Item Name: Crosstube Turning Detail

DART AEROSPACE LTD		Work Order:	116477
Description: Crosstube Assembly		Part Number:	D407-667-145
Inspection Dwg: D407-667-145 Rev: C		Page 1 of 2

DRAWING NO. D407-667-145	TITLE CROSSTUBE ASS'Y (407 HIGH FWD)	REV. C	DART AEROSPACE LTD ENGINEERING ORDER		D.E.O. NO. D407-667-145-C-1	SHEET NO. SHEET 1 OF 1	SCALE NTS
DRAWN <i>Q</i>	CHECKED <i>ASS</i>	MFG. APPR. <i>AB</i>	APPROVED <i>WD</i>		DE APPR. <i>##</i>		
DATE 11.07.15	DATE 11.07.22	DATE 11.07.22	DATE 11/07/22		DATE 11.07.21

DRAWING NO. D407-667-145	TITLE CROSSTUBE ASS'Y (407 HIGH FWD)	REV. C	DART AEROSPACE LTD ENGINEERING ORDER		D.E.O. NO. D407-667-145-C-2	SHEET NO. SHEET 1 OF 1	SCALE NTS
DRAWN AJS	CHECKED [Signature]	MFG. APPR. [Signature]	APPROVED [Signature]		DE APPR. [Signature]		
DATE 12.08.02	DATE 12.08.02	DATE 12.08.02	DATE 12.08.02		DATE 12.08.02

DETAIL P
BONDING STRAP INSTALLATION 2 PL

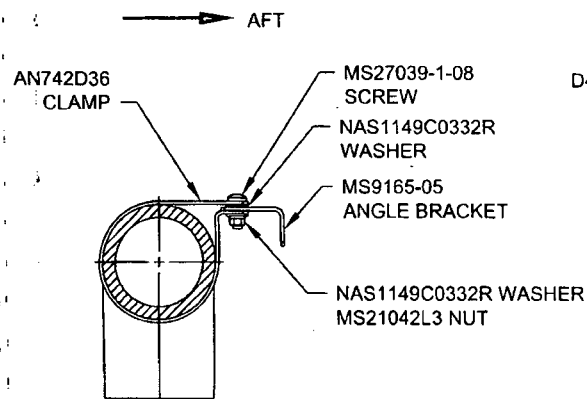
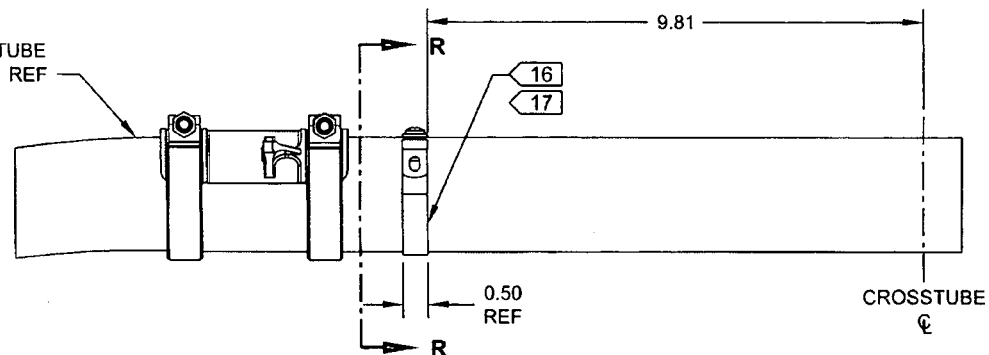
PURPOSE:

ADD ELECTRICAL GROUNDING STRAP

ITEM	QTY	PART NUMBER	DESCRIPTION
1	X	D407-667-145	CROSSTUBE ASSEMBLY (407 HIGH FWD)
10	2	AN742D36	CLAMP
11	2	MS9165-05	ANGLE BRACKET
12	2	MS21042L3	NUT (OR MS21042-3)
13	2	MS27039-1-08	SCREW
14	4	NAS1149C0332R	WASHER (OR AN960C10L)

- 16) MASK AREA UNDER CLAMP PRIOR TO PAINTING
- 17) SEAL EDGES WHERE AN742D36 CLAMP MEETS WITH THE CROSSTUBE USING SIKAFLEX-241/291 OR MIL-S-8802 CLASS B2 OR PROSEAL 890 SEALANT
- 18) PERFORM RESISTANCE CHECK TO ENSURE MAX RESISTANCE IS 10 MILLIOHMS
